# QUEEN STREET BUILDING

**Temporary Drainage Mark-Up**

SITE 3 - FORMER FAITH BUILDING

PROPOSED DRAINAGE

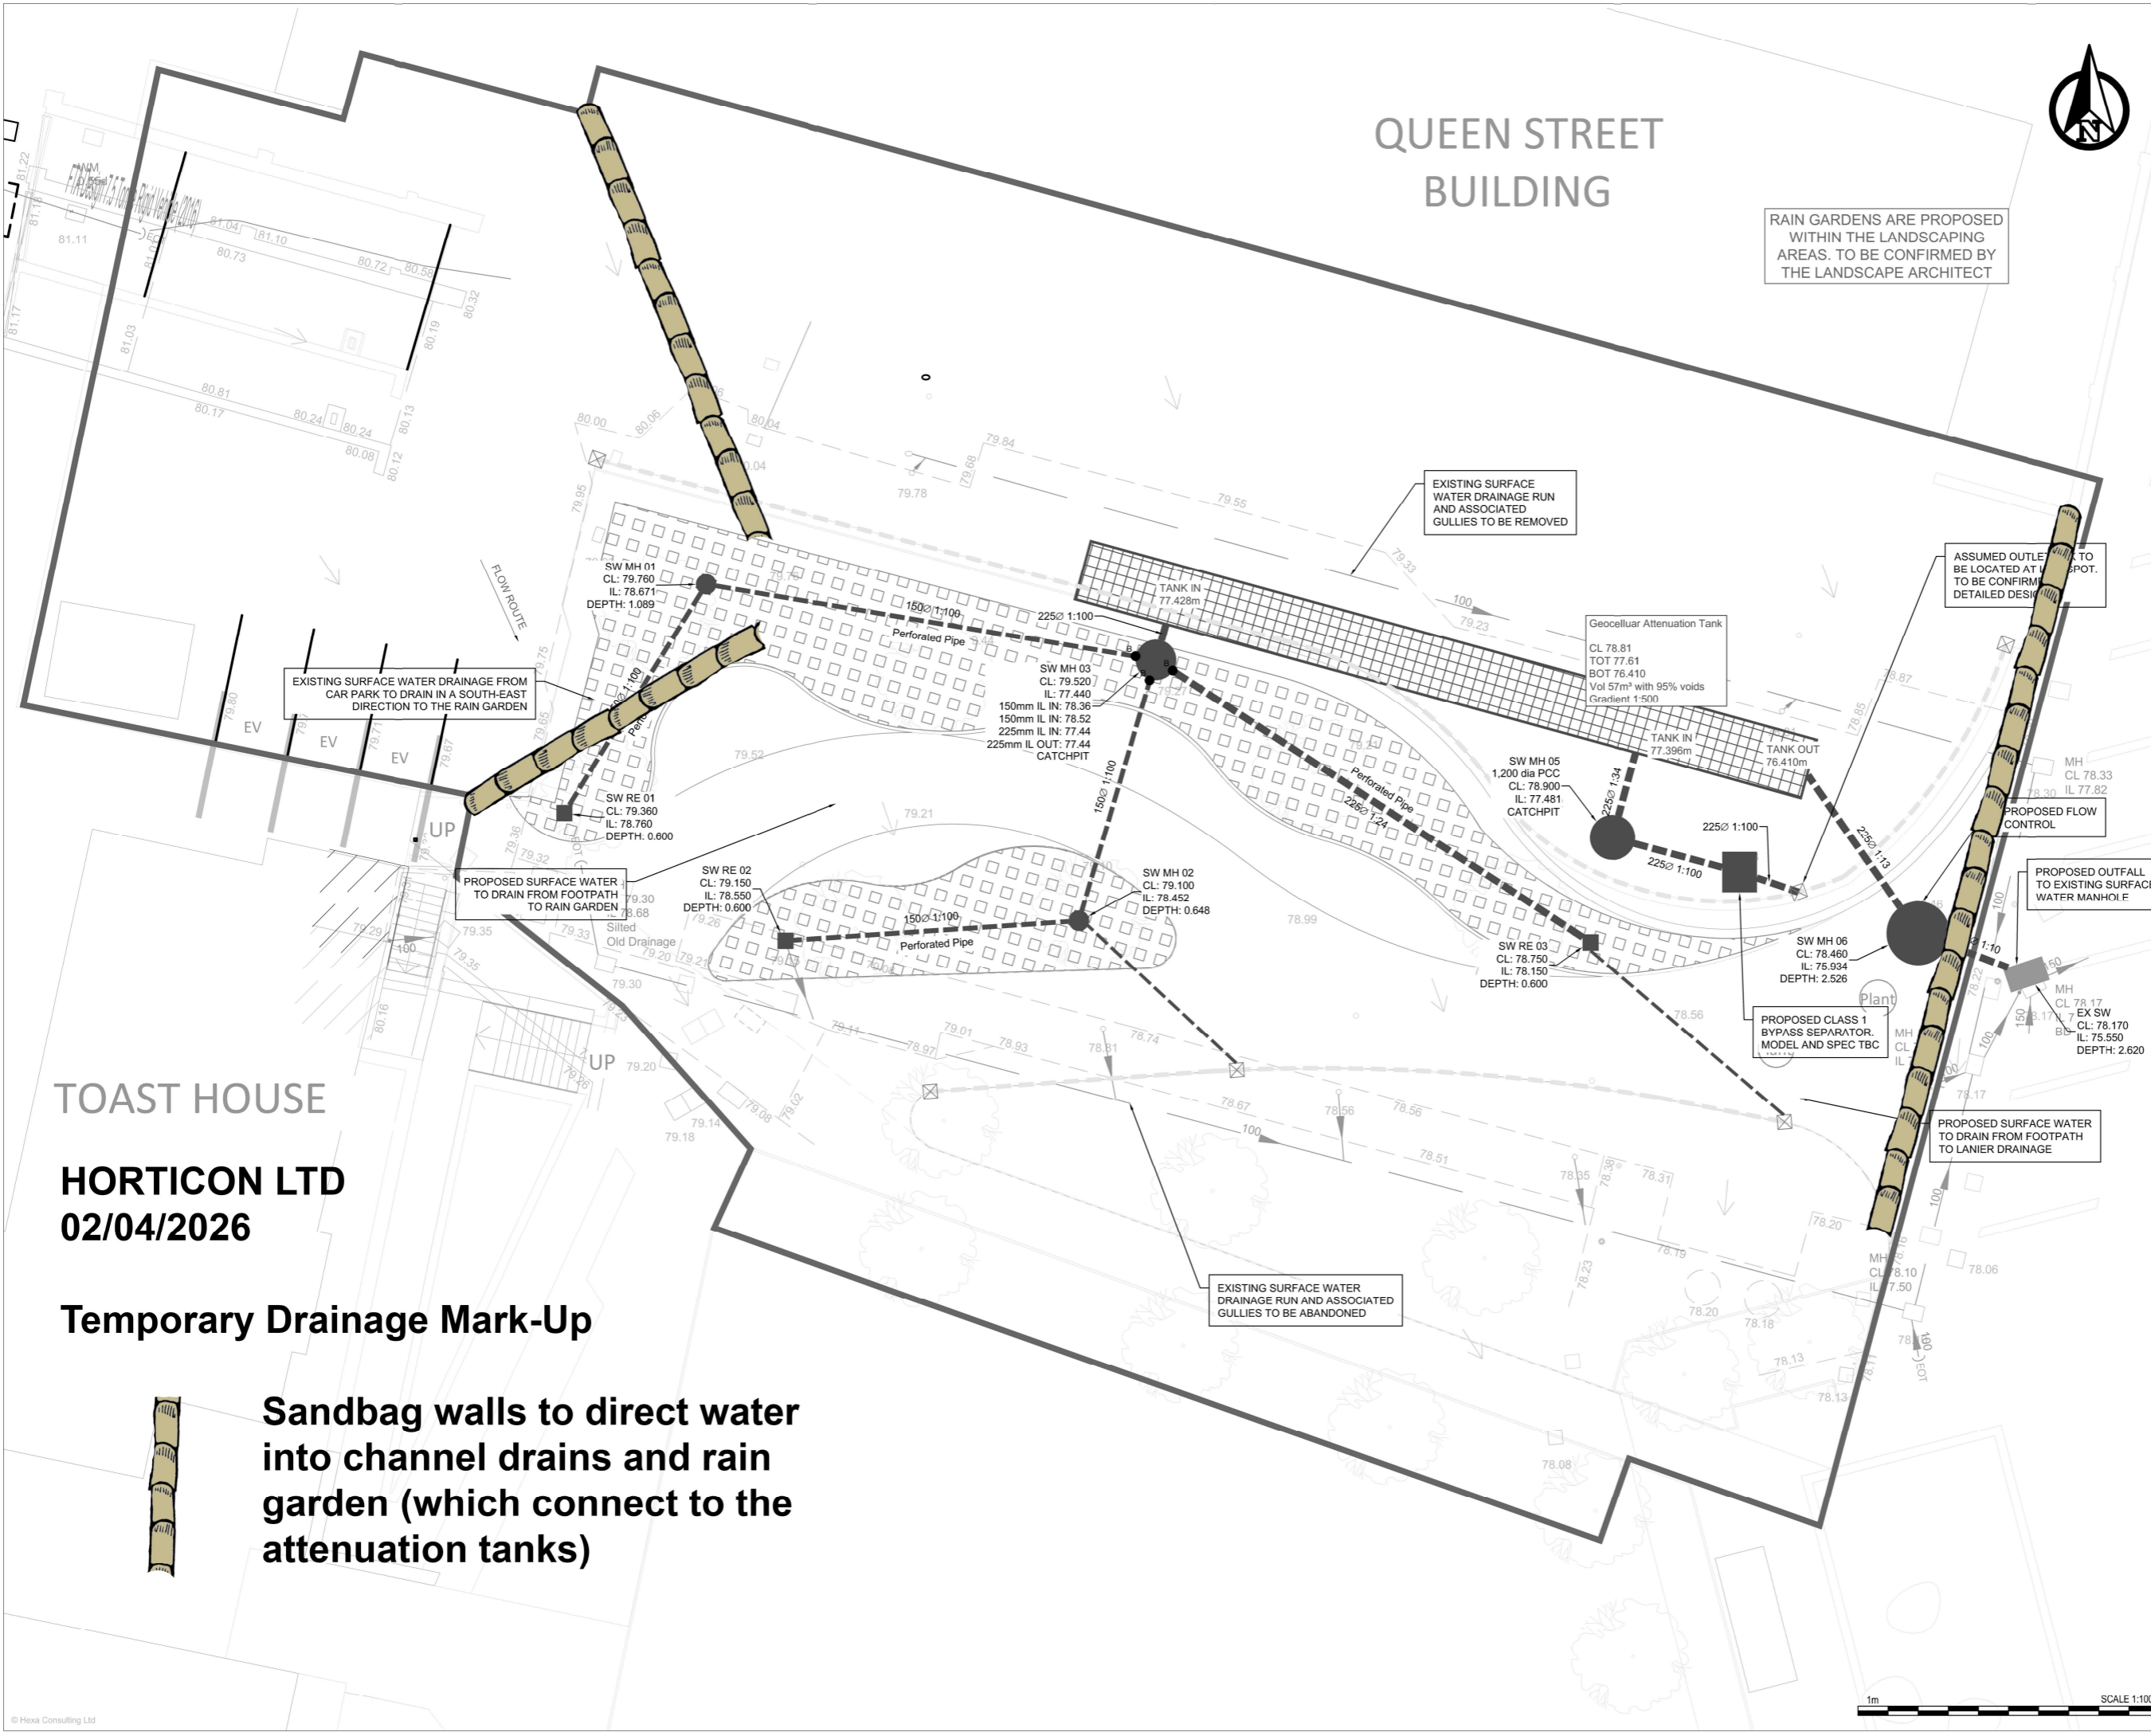
**Sandbag walls to direct water into channel drains and rain garden (which connect to the attenuation tanks)**
